# Access Compliance Report

## Public Rights-of-Way

### (Curb Ramps)

Intersection ID: 11600	Main Street: ALLEN_ST	Cross Street: PARKWOOD_AV	Location: SE
ADA ID: 3B06FB43F05A	Ramp Type: BlendTrans1	Initial Pass/Fail: Fail	Overall Compliance: No
Severity Score: 21.25			
Codes/Mitigation Info/Possible Solution		Field Measurements/Component Compliance

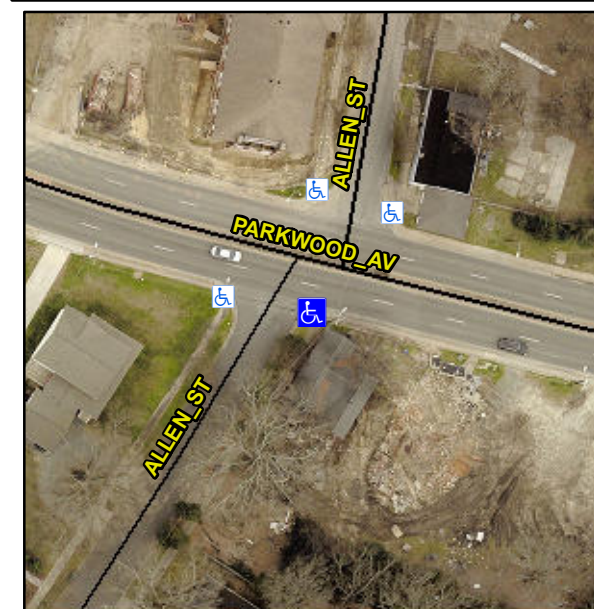
**Not Found, R304.5.1, R304.5.3**

Compliance	Description	Data	Compliance	Description	Data
N/A	Ramp Length (in)	62.0	Yes	BlendTrans Slope (%)	2.5
No	Ramp Width (in)	45.0	No	BlendTrans XSlope (%)	5.8
N/A	Flare Type LT	N/A	N/A	Flare Type RT	N/A
N/A	Flare Slope LT (%)	N/A	N/A	Flare Slope RT (%)	N/A
N/A	Flare Traversable LT?	N/A	N/A	Flare Traversable RT?	N/A
N/A	Landing Length (in)	N/A	N/A	DWS Provided?	N/A
N/A	Landing Width (in)	N/A	N/A	DWS Contrast?	N/A
N/A	Landing Slope (%)	N/A	N/A	DWS Length (in)	N/A
N/A	Landing X Slope (%)	N/A	N/A	DWS Full Width?	N/A
N/A	Landing Curb? (Y/N)	N/A	N/A	DWS Offset (in)	N/A
N/A	Shared Landing?	N/A			
N/A	Gutter Ponding?	N/A	N/A	Gutter Slope (%)	N/A
N/A	Gutter Lip Ht (in)	1.0	N/A	Gutter X Slope (%)	N/A
N/A	Painted X Walk1?	No	N/A	Painted X Walk2?	N/A
	X Walk 1 Direction	To W		X Walk 2 Direction	N/A
	X Walk 1 Width (in)	N/A		X Walk 2 Width (in)	N/A
	X Walk 1 Slope (%)	0.9		X Walk 2 Slope (%)	N/A
	X Walk 1 X Slope (%)	4.6		X Walk 2 X Slope (%)	N/A

N/A	Ramp inside XWalk1?	N/A	N/A	Ramp inside XWalk2?	N/A
	Road Slope (%)	4.6		Clear Space?	N/A
	Road X Slope (%)	0.9	N/A	Clear Space to XWalk (in)	N/A
N/A	Any Obstructions?	N/A	N/A	Storm Grate/Utility Hazard?	N/A
	Obstruction Type			Storm Grate/Utility Type	
		N/A			N/A
			Yes	Surface Condition? (G/P)	Good
			No	Curb Slope (%)	21.0

**Remove & Replace Curb Ramp With Two New Directional Ramps or Equivalent.**
